MEMORANDUM FOR: RECORD

July 9, 2015

SUBJECT: DETERMINATION REGARDING THE SUITABILITY OF PROPOSED DREDGED MATERIAL FROM GEORGIA-PACIFIC GYPSUM, EVALUATED UNDER SECTION 404 OF THE CLEAN WATER ACT, FOR UNCONFINED OPEN-WATER DISPOSAL AT THE COMMENCEMENT BAY NONDISPERSIVE SITE.

Figure 9

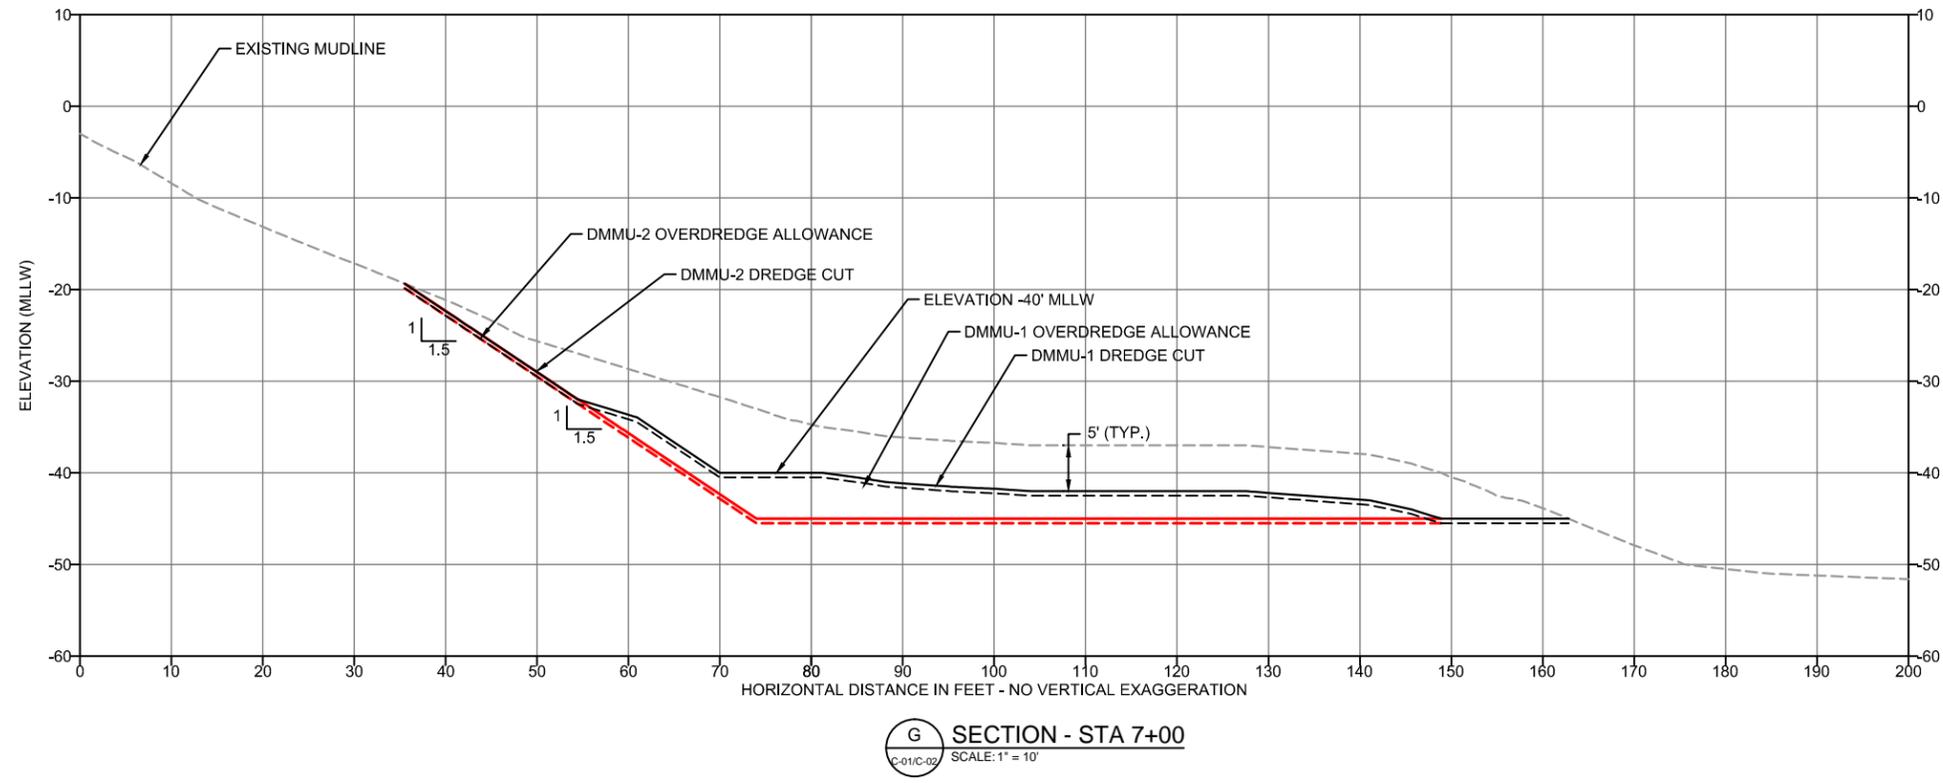
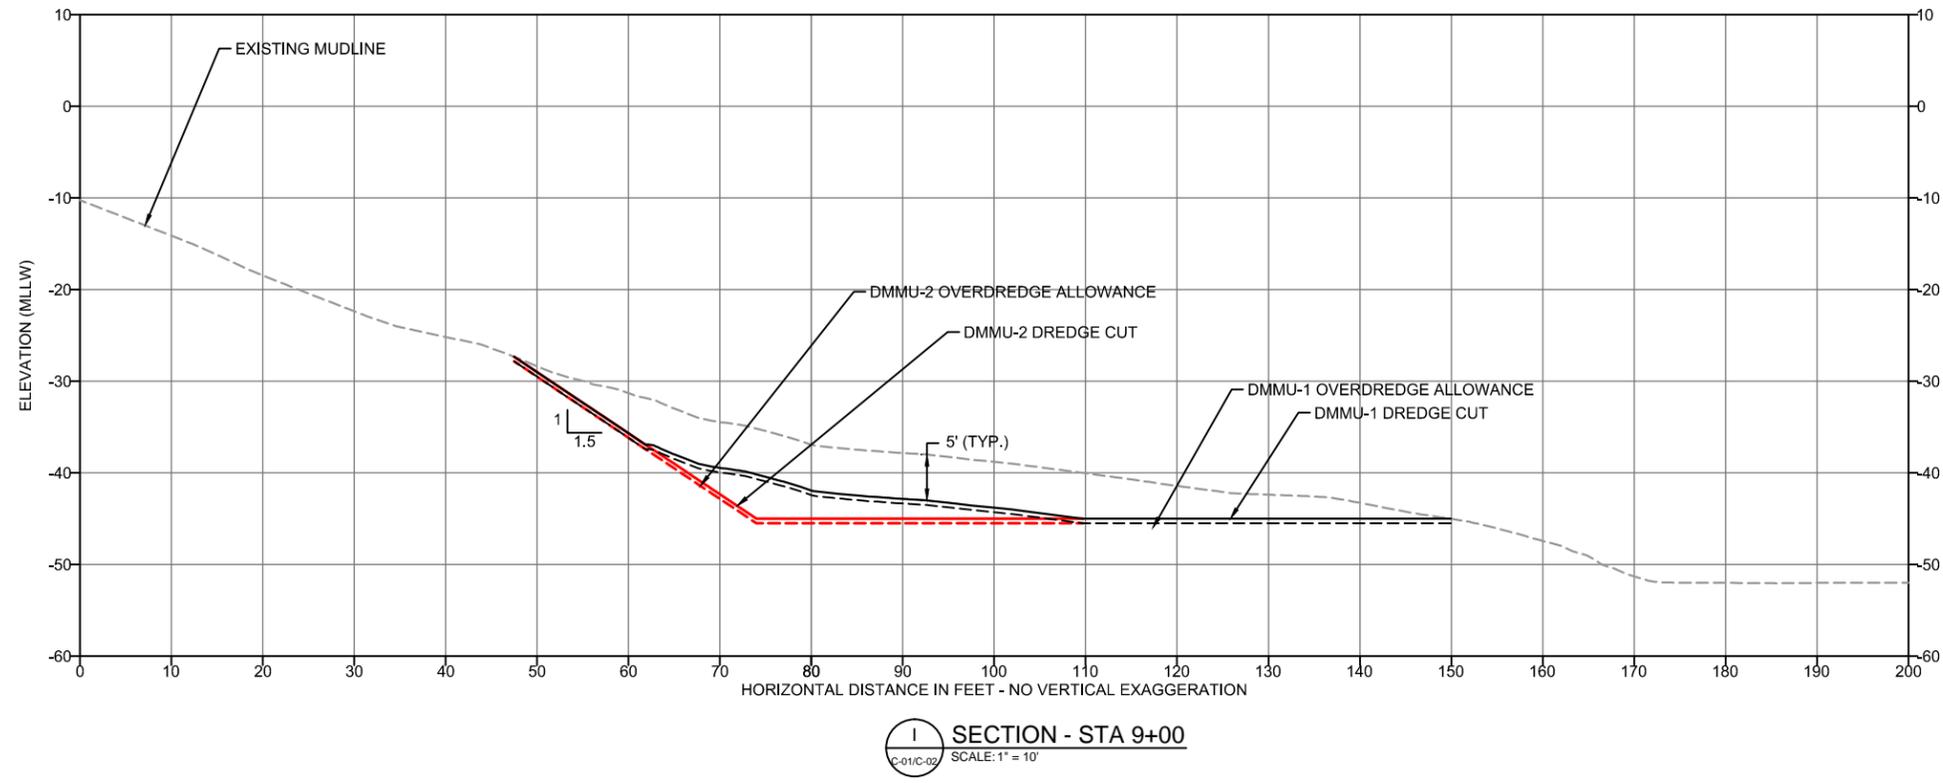
In order to adequately separate the unsuitable surface material from the suitable subsurface material during dredging, the DMMP agencies are requiring a one-foot vertical buffer be added to DMMU 1. This means that the surface five feet (not including overdepth), must be dredged and hauled to an upland disposal site. Once the surface material has been removed, the remaining sediment may be dredged and placed at the Commencement Bay open-water disposal site.

GPG has submitted a preliminary dredge design (Figures 4 to 10) that includes the one-foot buffer. The dredge prism also includes other changes from what was presented in the SAP. In order to minimize potential impacts to Graymont Incorporated's dock to the northwest, the northern extent of the dredge prism was reduced. In addition, the overall dredge depth was changed to -45.5 ft from the depth of -45.0 ft included in the SAP. The design depth is now -45.0 ft plus a 0.5 ft overdredge allowance.

The modifications made to the dredge plan resulted in an overall reduction in the total volume from 28,710 cy to 25,450 cy. Due to the addition of the one-foot buffer, the volume of DMMU 1 increased from 14,330 to 16,900 cy. The subsurface volume included in DMMU 2 shrank to 8,550 cy.

In summary, based on the results of the previously described testing, the DMMP agencies concluded that the **16,900 cubic yards of dredged material in DMMU 1 are unsuitable for open-water disposal, while the 8,550 cy in DMMU 2 are suitable for open-water disposal at the Commencement Bay non-dispersive site.**
